APPEAL PACKET FORM

Action Being Appealed: Approval of the Walt Ranch EIR, its findings, and the statement of overriding considerations.

Re: Napa County Planning Division Approval of Walt Ranch Environmental Impact Report

The Center for Biological Diversity challenges Napa County's (County) decision to certify and approve the Walt Ranch vineyard (project) environmental impact report (EIR) and its corresponding Erosion Control Plan (application number P11-00205-ECPA). This project will cause severe environmental impacts to biological resources, traffic, water supply and quality, air quality, and the climate that the EIR fails to adequately discuss and mitigate. For the reasons outlined below, the County must revoke its approval of the Erosion Control Plan and revise its EIR in order to fully comply with the California Environmental Quality Act (CEQA) and other applicable state and federal laws.

Figure 1 – Ideal Wildlife Friendly Fence

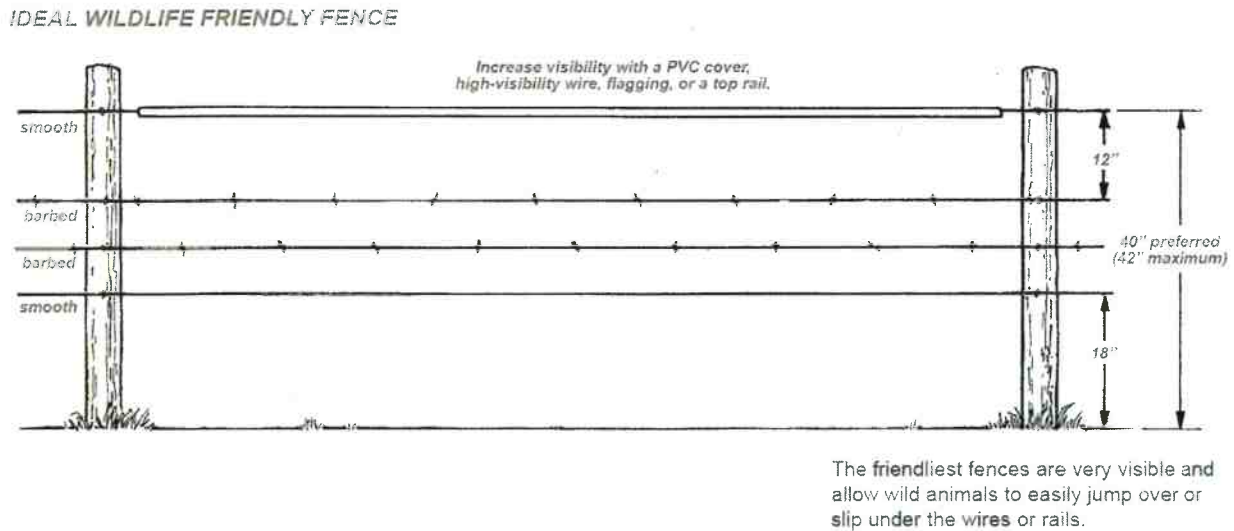
Because death is, by any measure, a significant “reduction of wildlife movement,” the conservation groups request that the County take this threat seriously and in accordance with Napa County’s General Plan Policies. (Napa County General Plan CON-29 (discussing Policy CON-18).) Therefore, the conservation groups asks that the County either entirely prohibit the planned fencing at Walt Ranch, or, at a minimum, require the Applicant to only install ecologically friendly fencing to the extent that prohibiting fencing is infeasible.

Figure 2: Contra Costa goldfields habitat overlaid with a map of Walt Ranch

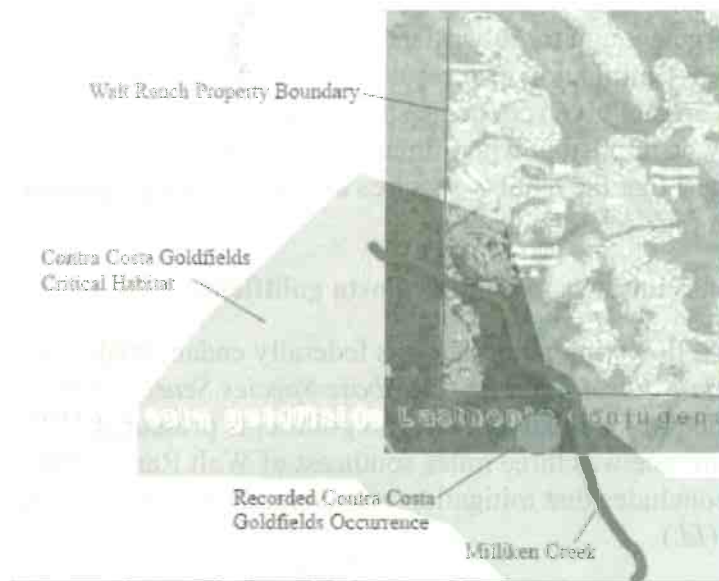
The DEIR recognizes that goldfields habitat was present at Walt Ranch, but fails to mention goldfields critical habitat either within or surrounding Walt Ranch. (See DEIR 4.2-31, 4.2-47.) The DEIR also does not address the recorded goldfields present immediately South of Walt Ranch. (*Id.*; Fig. 2, *supra.*) Milliken Creek runs through Walt Ranch and then continues directly into the goldfields' critical habitat and through the area where goldfields have been located. (See Fig. 2, *supra.*)

To set an acceptable baseline against which to measure the Project's impacts, Napa County needs to discuss the goldfields' critical habitat both on and near Walt Ranch. (CEQA Guidelines § 15125(a).) Because the County has failed to provide an adequate baseline, its nonexistent discussion of impact significance also fails the standards set by CEQA. (*Woodward Park Homeowners Assn, Inc. v. City of Fresno* (2007) 150 Cal.App.4th 683, 687; CEQA Guidelines § 15125(a) & (e).) In the next draft of the EIR, the County should discuss potential impacts to on-site goldfields critical habitat and the potential for negative downstream effects of continued vineyard operations at Walt Ranch. The County should also mandate mitigation for these effects so that they are below a significant level. (CEQA Guidelines §§ 15126, 15126.6.) Specifically, we request that all proposed vineyard plots within or near the goldfields' critical habitat not be developed, and that all potential goldfields habitat on-site be improved and set aside for conservation. Also, the County should prohibit all herbicide use that may wash or drift into Milliken Creek or other parts of the goldfields' critical habitat. The next draft of the EIR should also discuss any additional federal permits the Applicant needs to develop on the goldfield's critical habitat, such as a federal ITP. The County should also discuss whether Section 7 ESA consultation is required for the County to approve the Applicant's erosion control permit.
